Process Sheet

Customer : CU-DAR001 Dart Helicopters Services	Drawing Name : HELI UTILITY BASKET LH/RH 350/355
Job Number : 38726	
Estimate Number : 10208	
P.O. Number :	Part Number : D350607043
This Issue : 22/04/2008 S.O. No. :	Drawing Number : D350-607 REV F P7-9
Prsht Rev. : NC	Project Number : N/A
First Issue : // Type : LARGE FAB ASSY	Drawing Revision : F
Previous Run : 38725	Material :
Written By :	Due Date : 10/05/2008 Qty: 1 Um: Each
Checked & Approved By : <u>JLD 08.4.02</u>	
Comment : Est Rev:E as Per DSI9318 06-01-24 JLM	
Est Rev:F ECN1068 07-12-21 DD verified by:

DART SERVICE INSTRUCTION

TO AMEND INSTALLATION INSTRUCTIONS D350-607 REV. F

DESIGN DS	DRAWN BY PH	DART	DART AEROSPACE LTD. HAWKESBURY, ONTARIO, CANADA
CHECKED PH	APPROVED PH	DRAWING NO. D2989	REV. B SHEET 3 OF 3
DATE 05.06.07	TITLE BASKET LID ASSEMBLY	SCALE 1:10

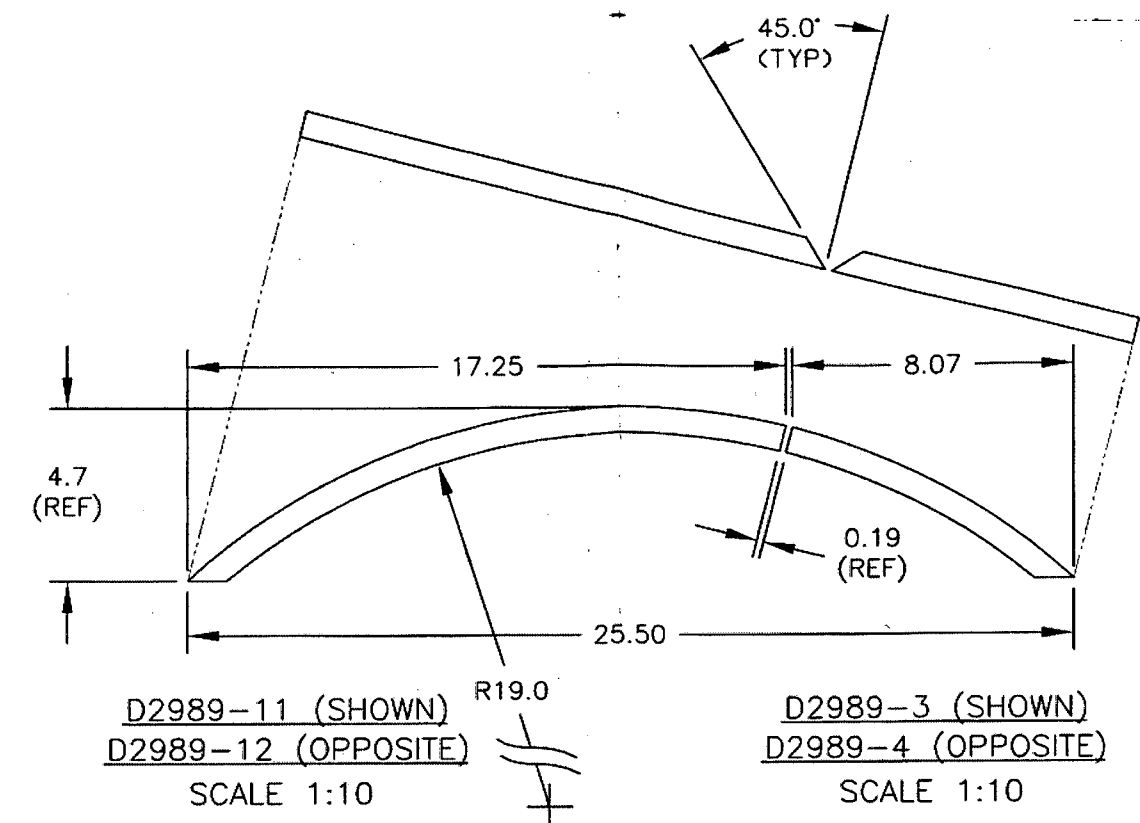
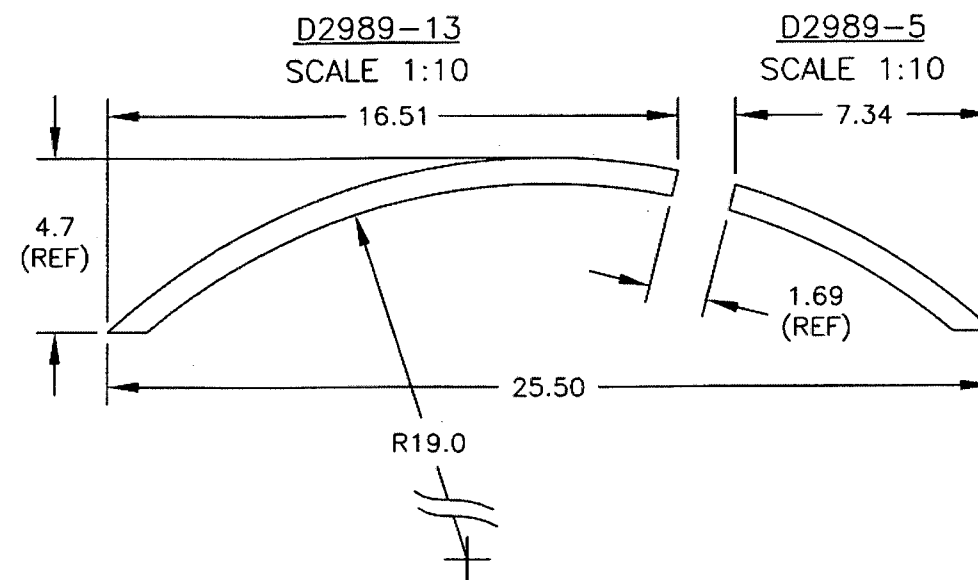
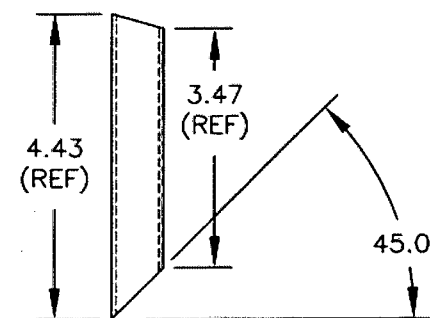
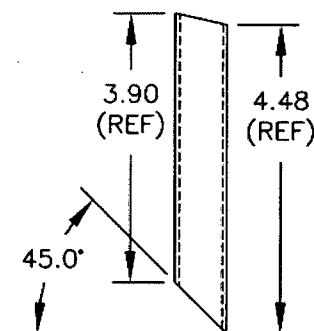
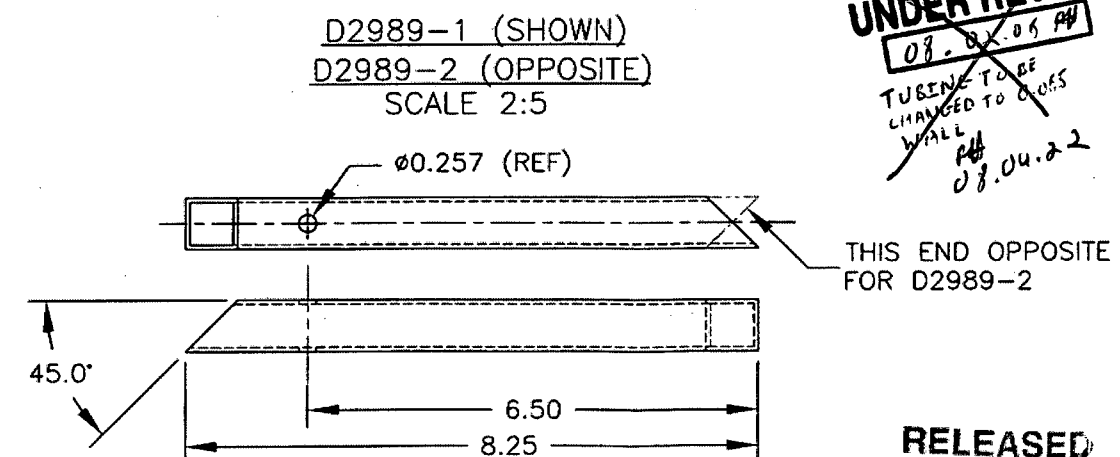
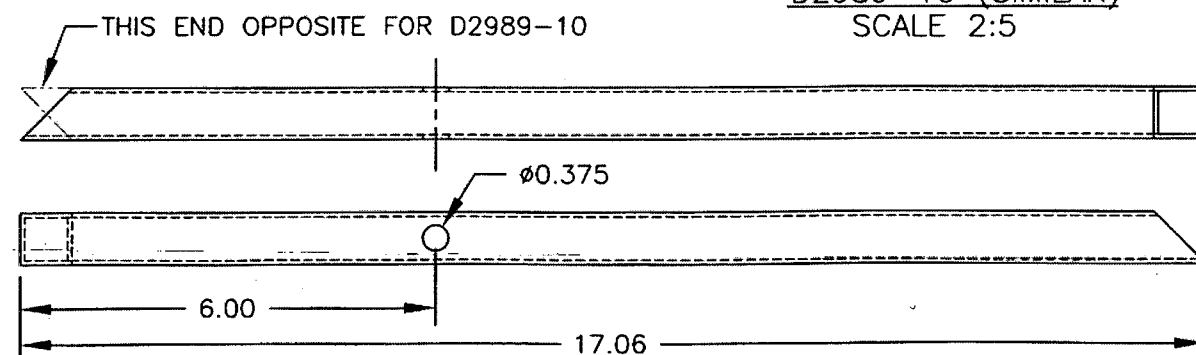
UNDER REVIEW
08.08.06 PH
TUBING TO BE
CHANGED TO 0.065
WALL
PH
08.04.22
